Nomad

SERVICE BULLETIN

CONTROL SYSTEM – IMPROVED PULLEY MOUNTING AT STATION 67.95 (MOD N137)

Figure 1

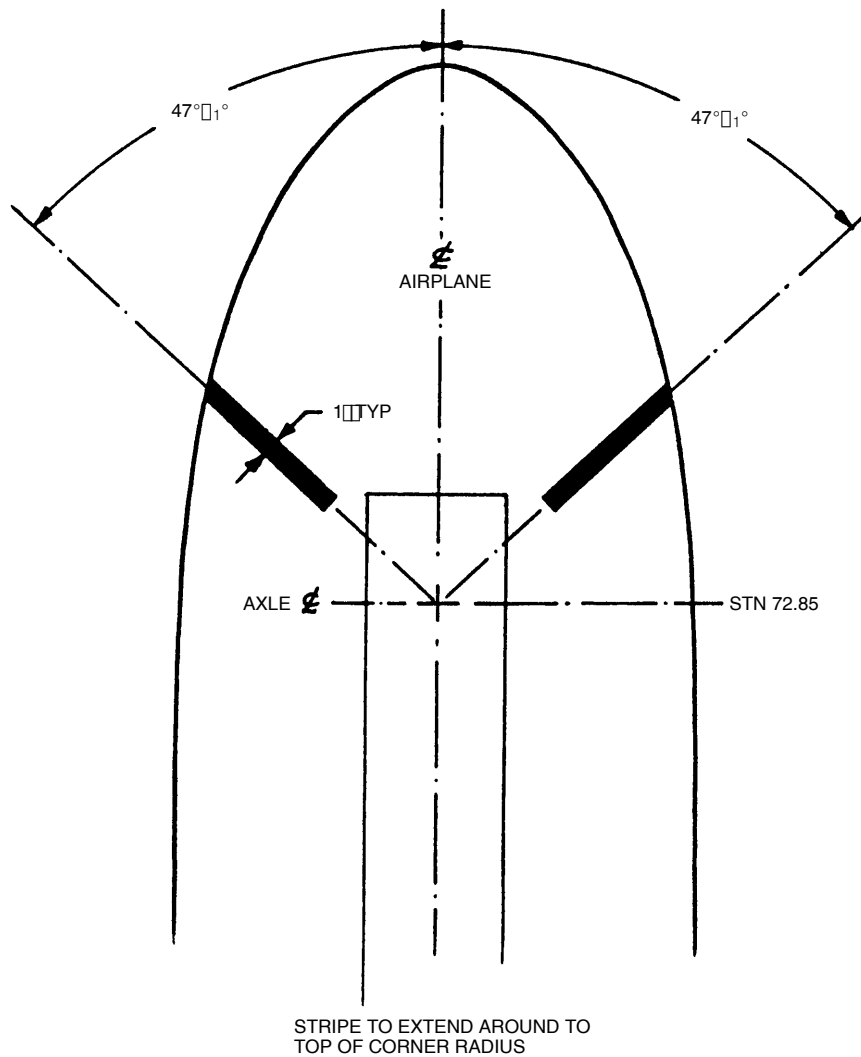
- I. Check rig rudder control system (Ref MM Chap 27-20-00).
- J. Painting of Towing Indicator Marks
- Refer Paragraph 1 (d), Chap 9-00-00 Page 1 of Maintenance Manual which limits tow bar angle to 49 deg. either side of aircraft centre line. Paint two yellow stripes under nose of aircraft as defined in Fig 1 of this Service Bulletin.
